Wolfe's Neck Woods State Park - Freeport, Maine

Department of Agriculture, Conservation and Forestry-Bureau of Parks and Lands
Project Number BGS-3510

Addendum - 01

October 11, 2024

M-101

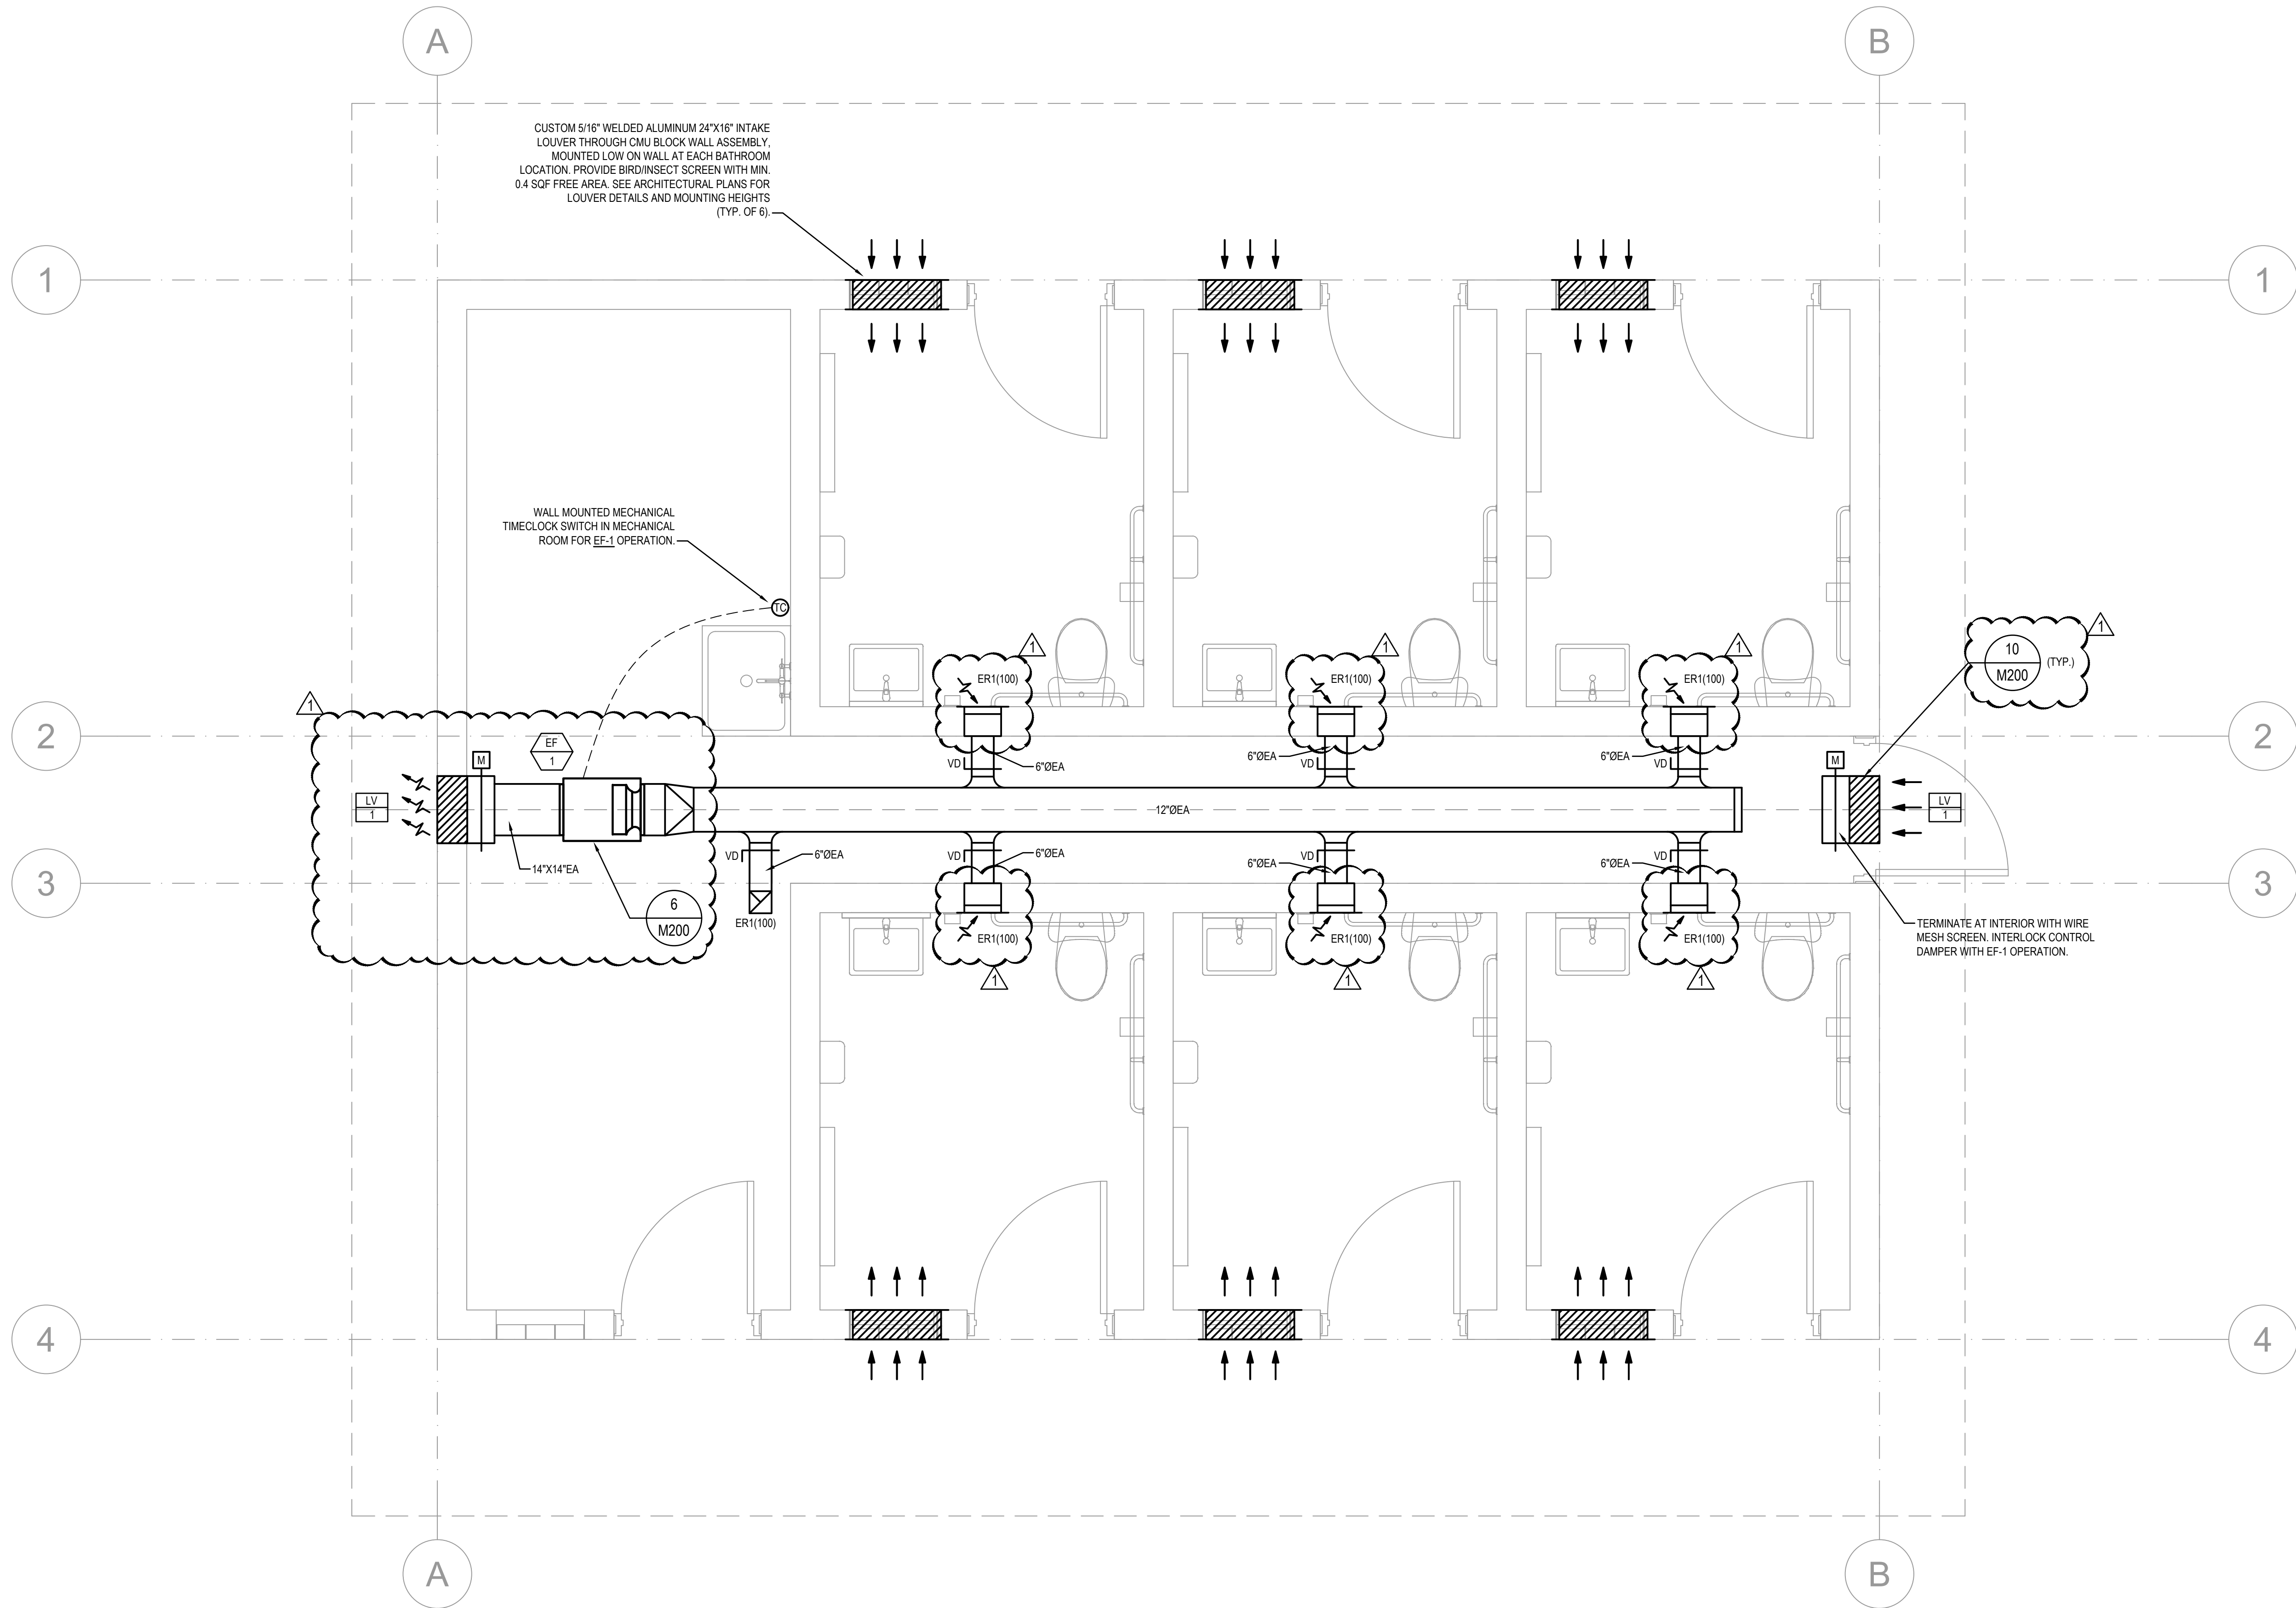
- **Response:** Yes, the proposed alternative is acceptable, provided the nominal thickness is 0.22 inches or greater.
 - **Question 4:** 1. Louvers – The 6 low wall louvers that are detailed on drawing A-5.1 and scheduled on drawing A-8.1 are also noted on drawing M-101. Please confirm that these will be provided the general contractor.

2. Louver Schedule – On drawing M-002 the schedule list a quantity of 6 L-2 louvers. I am only seeing 2 on drawing M-101. Please confirm the quantity of L-2 louvers.

- **Response:** The GC is responsible for providing the louvers as drawn per A-5.1. See attached Addendum-01 mechanical drawings for the bathhouse. The interior louvers have been replaced with grills, and there are two exterior louvers required. All of the changes are clouded.
